GENERAL APPLICATION

Location Address: 1604 Cleveland St. Hollywood, FL 33020

The following are the responses to your plans review comments of the above mentioned project:

NEW TOWNHOUSE FOR:
CLEVELAND HOMES LLC.
1604-1606 CLEVELAND ST.
HOLLYWOOD, FL 33020

1 EAST CONTEXT ELEVATION
1/16" = 1'-0"

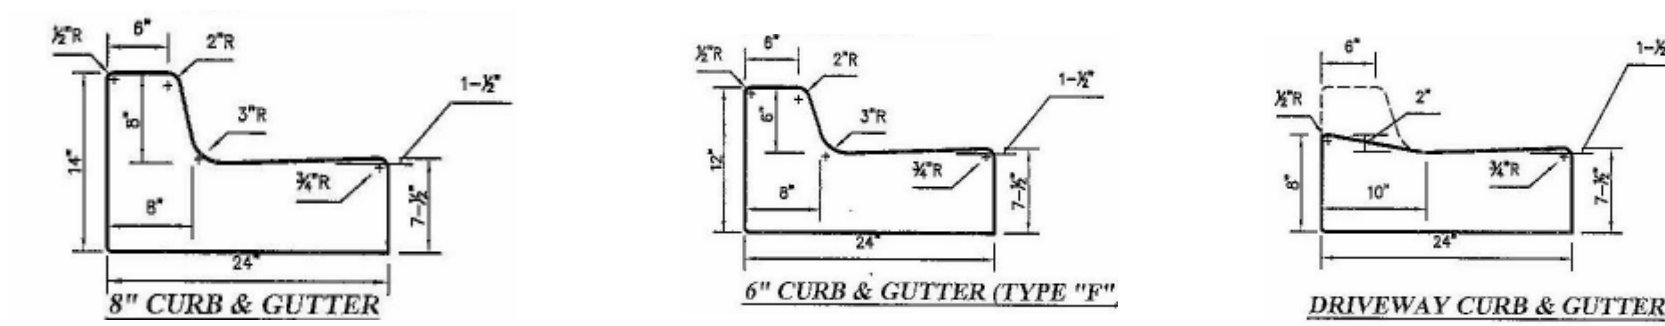
10. Provide a Street Profile with next submittal. Ensure elevations show the general character and relationship with surrounding properties.

R: Street Profile now provided, see sheet A0.7.

2 DUMPSTER ENCLOSURE WALL DETAIL
1/2" = 1'-0"

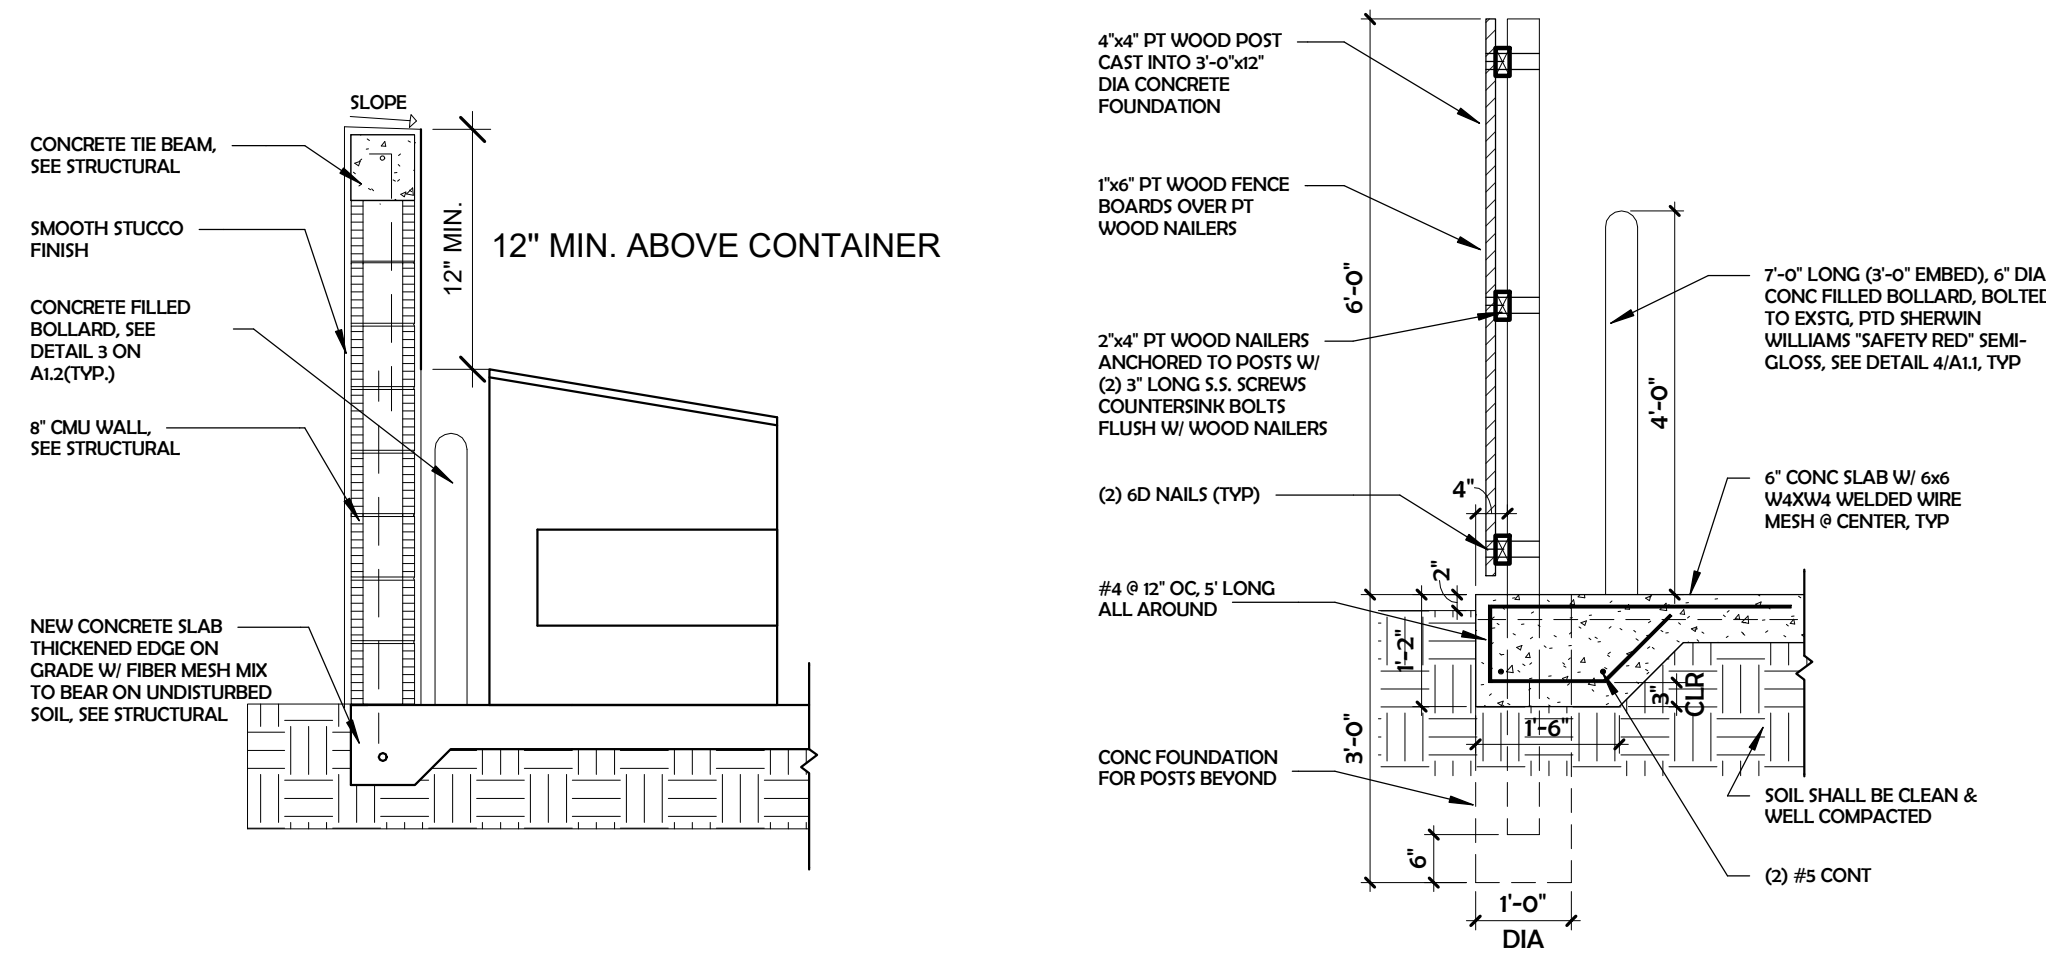
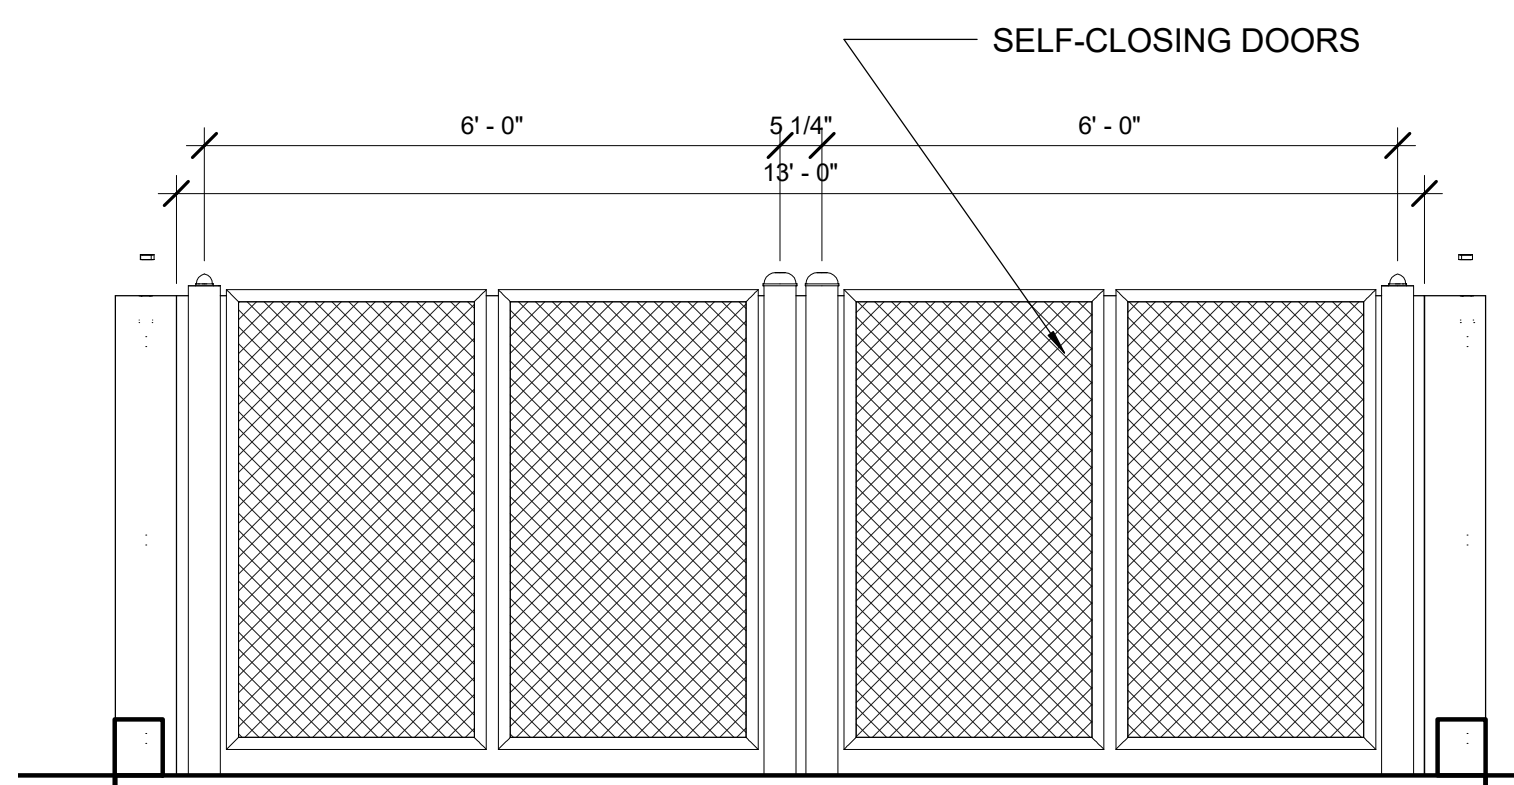
6. Provide dumpster enclosure details.

R: provided on site plan A-1.0

1 SITE PLAN
1/8" = 1'-0"

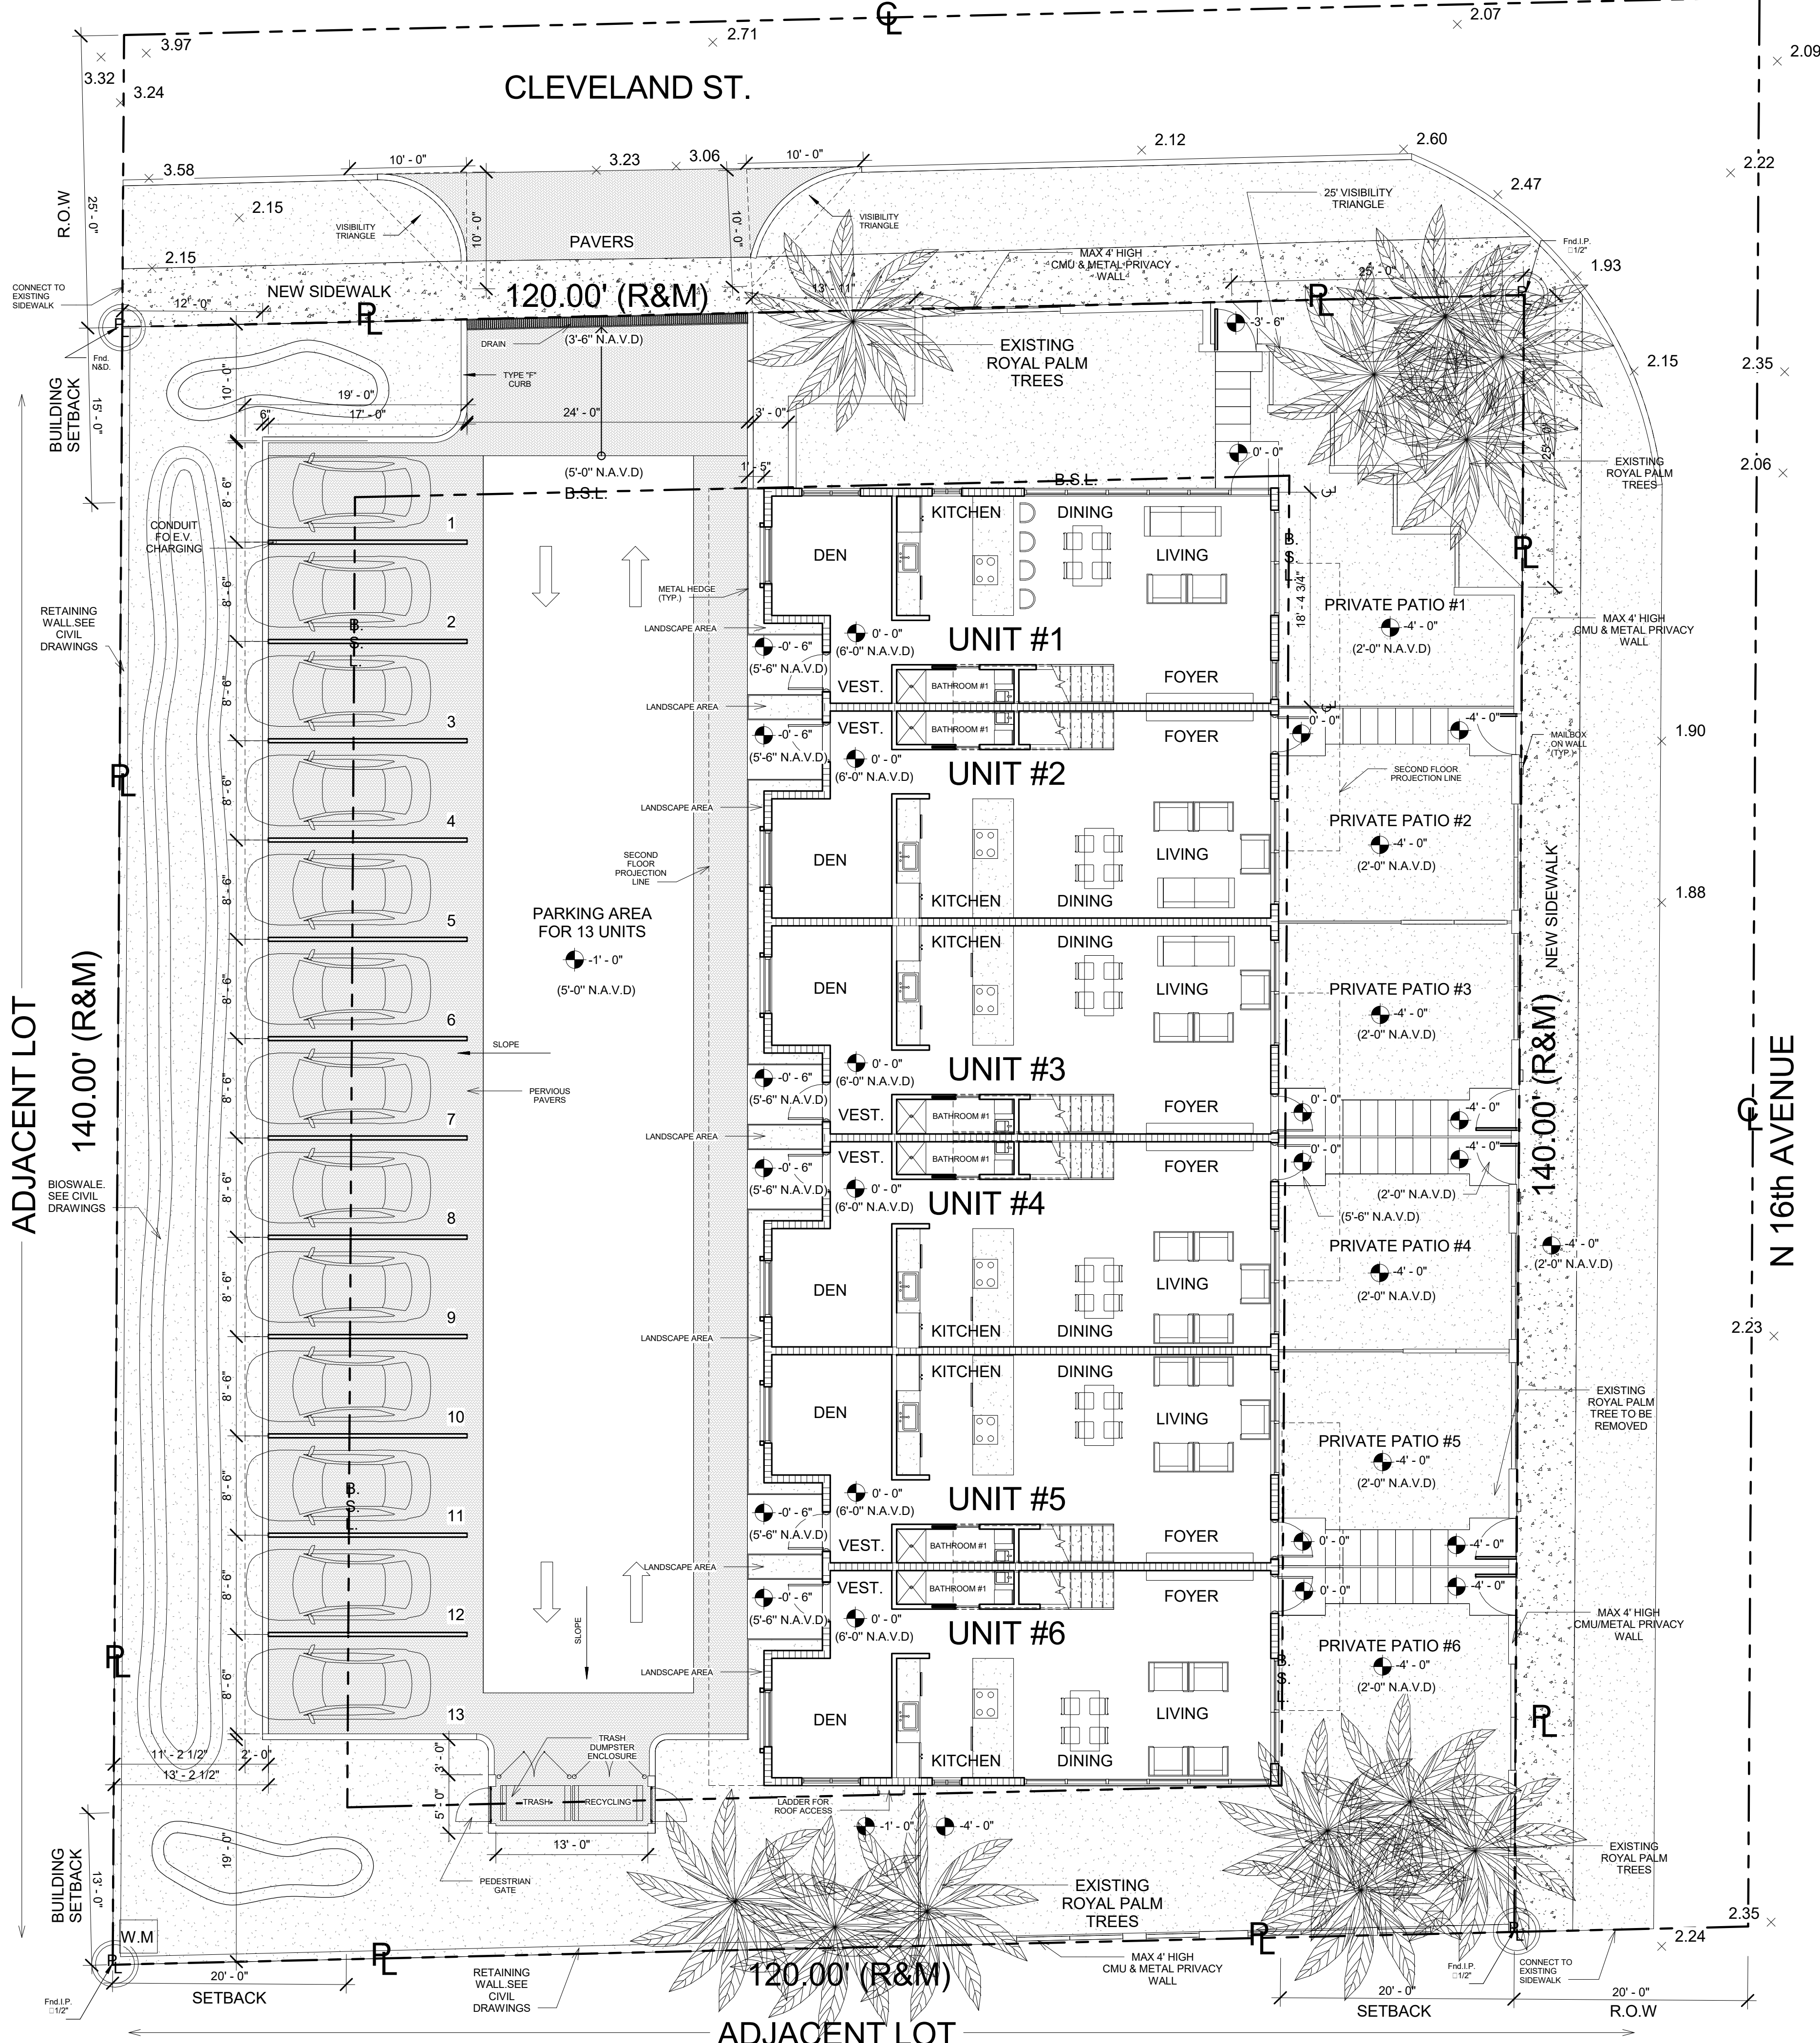
1. Provide the setback dimensions of the at-grade parking lot from the north and south plot lines.

3. Provide the width of the curb cut proposed on Cleveland Street.

13. Provide the finished floor elevation on the Site Plan, and ensure it is accurately illustrated on the building elevations.

1. Sheet A1.0: How will the "Turf Block" area be maintained. Is grass being used? No landscape plans were included for review.

2. Sheet A1.0: The east entry walk does not connect to the sidewalk along SW 16th Avenue.

3. Sheet A1.0: Dumpster enclosure details were not included for review. Gates are required and how is recycling be accommodated.

4. Sheet A1.0: You cannot have more than 10 parking spaces without a landscape island.

5. Indicate width of driveway opening on Sheet A1.0.
Sheet A1.0 shows for a wall at the property line, be sure wall footings are within the property.
R: Driveway width indicated.

11. Sheet A1.0, sidewalk from the south side of Unit #6 transpasses to the adjacent private property.
R: Corrected.
12. Indicate setback between the parking area and the north and south property lines.
R: See revised site plan.

13. Indicate the depth of the turnaround space of the dead end drive aisle on Sheet A1.0.
R: See revised site plan.
14. Sheet A1.0, thirteen continuous parking stalls requires a landscape island.
R: Parking needs to remain as shown on site plan.

15. On Sheet A1.0, what is "Turf Black"? Is turn blocks being proposed? Provide detail for the material.
R: Turf black removed.
16. Clarify what the "B.S.L." line is on Sheet A1.0.
R: Clarified.

3. Sheet A1.0:

- a. Plans show 4' wall around rear/side yards. Is the remainder of the property fenced? Is the parking area gated?
- b. Provide more back-out area for parking space #13
- c. Identify handicapped parking space(s) and show accessible path to front doors of units
- d. Relocate dumpster enclosure to interior of property and away from street
- e. Show room dimensions
- f. Clarify whether the first floor bathroom has a toilet. Consider converting to powder room only, without toilet.
- g. Clarify the term "turf black"
- h. Clarify how the private patios of Units #1 & #6 are accessed from side doors. Is there a paved walkway from the door to patio?

R: Setback dimensions provided, see sheet A1.0

R: Curb cut dimension provided, see sheet A1.0

R: Finished floor elevations shown, see sheet A1.0

R: Revised, see site plan.

R: See revised Plans.
